Submission - Elizabeth St Retail Precinct – Midtown Streetscape Upgrade Project

Cycling South has reviewed the plans and provided feedback and comments below:

Block 1 – Melville St to Brisbane St

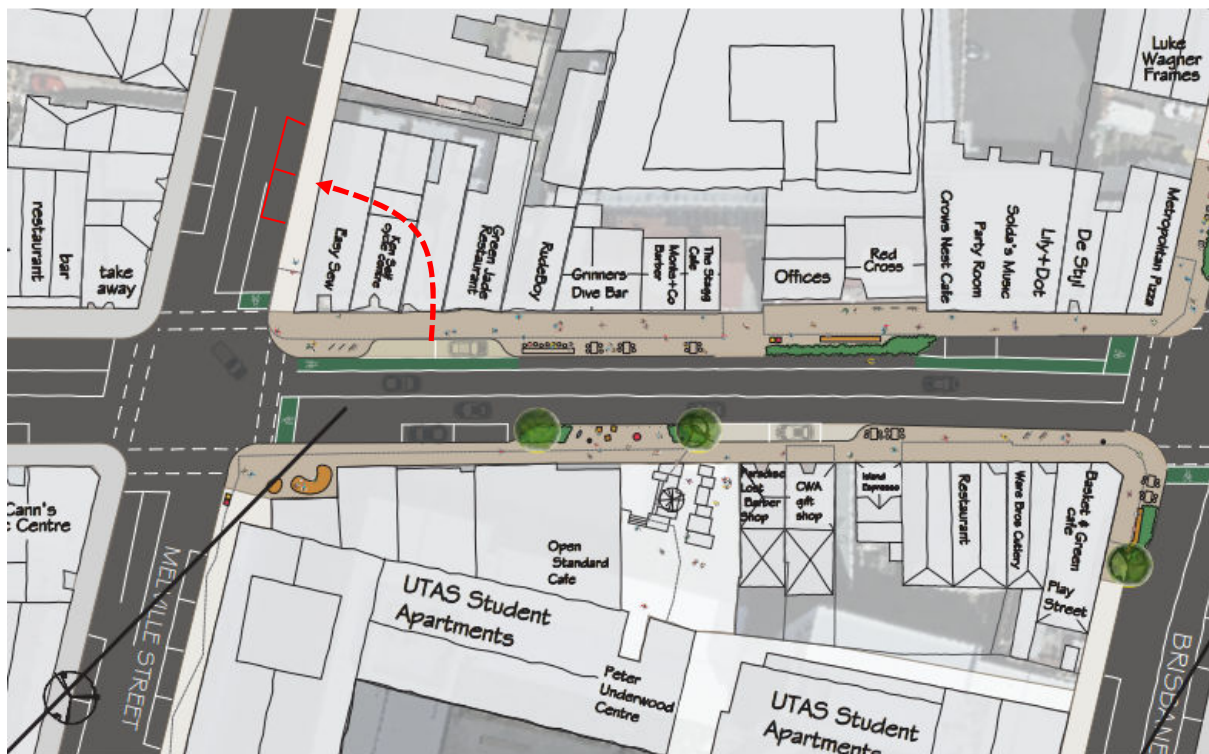
- Support the increase in footpath space, with kerbside 1.5m wide bike lane adjacent.

- The bike lane should meet the Austroads recommendations of 1.5m in width.

- Consider relocating 2 car parking bays in front of Ken Self and Green Jade Restaurant to Melville St, to reduce the risk of “dooring” to bike riders. The 2 relocated spots would still allow for two traffic lanes on Melville St at the intersection. The laneway behind Ken Self and Green Jade restaurant provides rear access for deliveries (and there is a loading zone on Melville St adjacent to the laneway) and the relocated parking spots still allow for customer pick up of bikes and sewing machines. The wider footpath area on Elizabeth St can be used for bike parking and outdoor dining.

- To prevent “squeezing” bike riders using Brisbane St as they cross the Elizabeth St intersection, install a kerbside approach and departure bike lane across the intersection.

Block 2 – Brisbane St to Patrick St

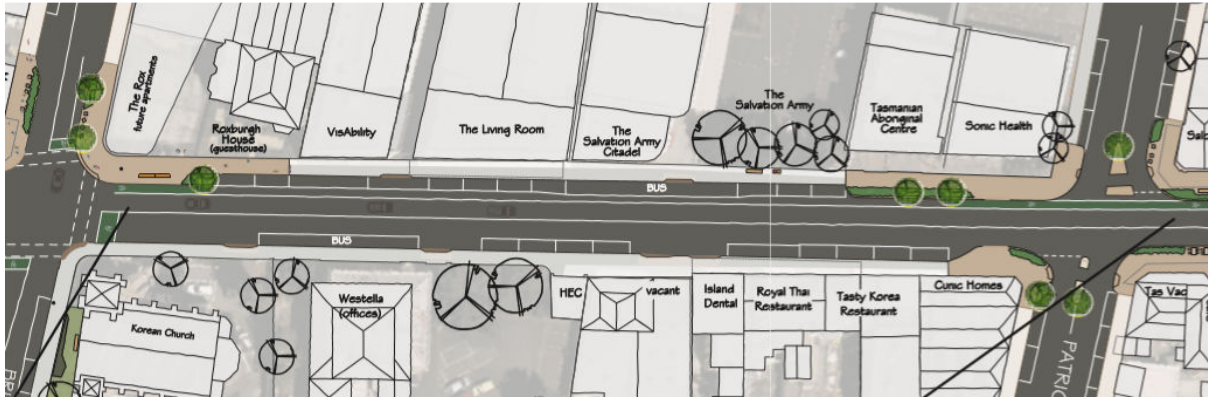
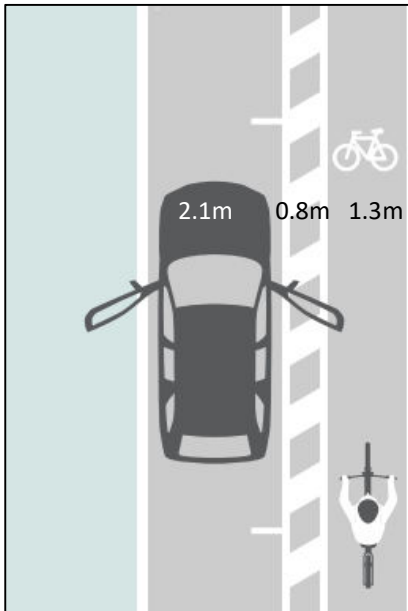
- With 9 car parking spots on the uphill side of this block it would be preferable to have a buffer between the parked cars and the bike lane. A potential configuration of lanes, based on the *City of Melbourne Bike Lane Design Guide* is listed below. Road width is approximately 12.4m.

2.1m parking lane (alongside chevron)

0.8m chevron

1.3m bike lane*

3.0m travel lane

3.1m travel lane

2.1m parking lane

* the bike lane can be narrower than 1.5m if a chevron is painted adjacent.

Block 3 – Patrick St to Warwick St

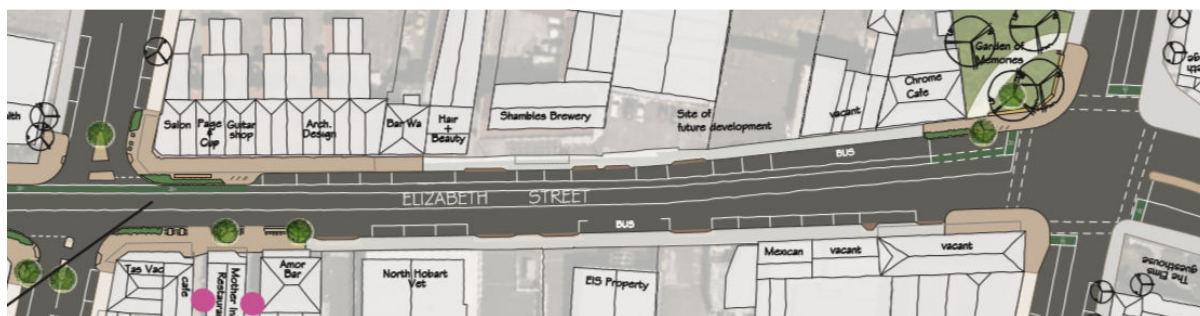
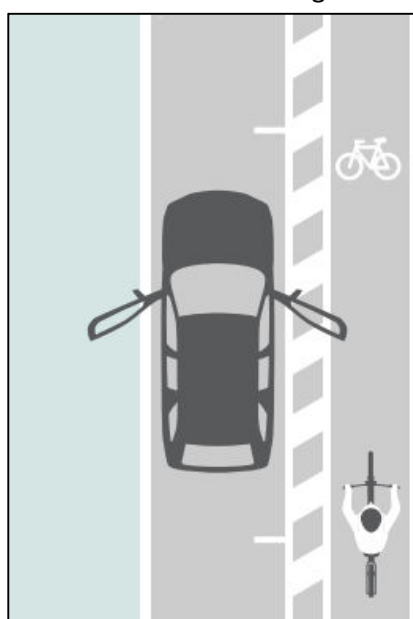
- As there are a number of car parking spots along the uphill side of the street, a chevron on the parking side of the bike lane would be appropriate (same treatment as block 2) to reduce the risk of “dooring” to bike riders.

- Support the widening of footpaths at Patrick St end. Since the intersection is unsignalised, the installation of raised crossings at the Patrick St intersection would enhance priority for pedestrians and traffic calm.

Warwick St intersection

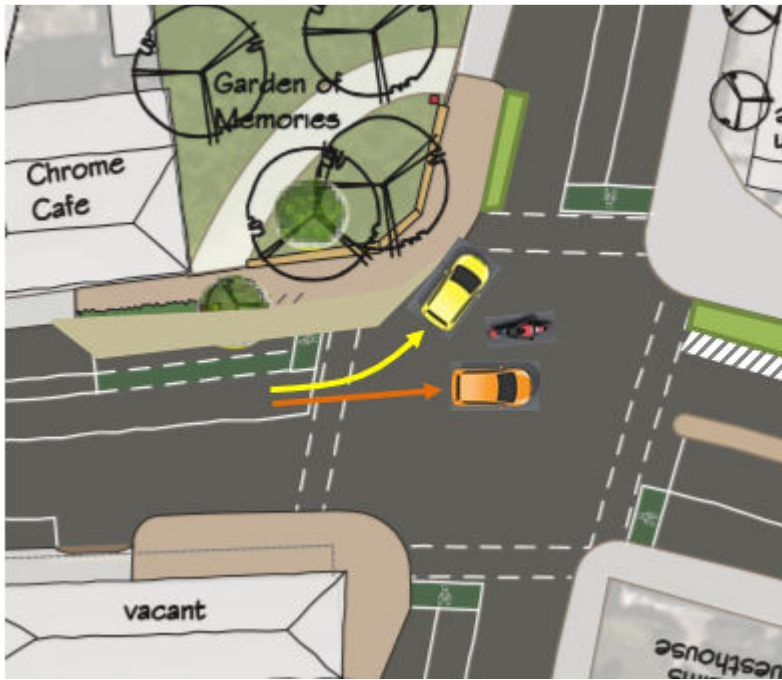
- Is the left turn lane from Elizabeth St into Warwick St necessary by the Garden of Memories? The space allocated for a left turning vehicle could be reallocated to the pedestrian traffic at that intersection, particularly Elizabeth College students waiting for the bus. It would also make the bike lane safer by preventing cars from cutting up the inside and would offer additional space to allow for a lane separator to prevent left turning cars from entering the bike lane. A left turning car can prop at the Warwick St pedestrian crossing without holding up the through traffic on Elizabeth St. Are there many right turning vehicles heading NE onto Warwick St? It may be possible to provide a dedicated right turn lane due to the extra width at the intersection.

- There is space on the northern side of the intersection for a departure bike lane on Elizabeth St outside Elizabeth College. This would make the intersection easier to navigate on a bicycle by defining the travel lane and allocating cycling space adjacent to the kerb, with a chevron buffer alongside.

- There is potential to widen the footpath in front of Chrome Café and adjoining shop fronts if the bus stop was relocated so it is directly outside Elizabeth College on the NW side of the intersection. This would require consideration of the concrete median and lane widths so that cycling is accommodated, but is outside the scope of the Mid-town project.

- Any kerb outstands should leave space for bicycle traffic, such as the departure side of the intersection of Warwick St by the Garden of Memories, in the form of a bike lane.
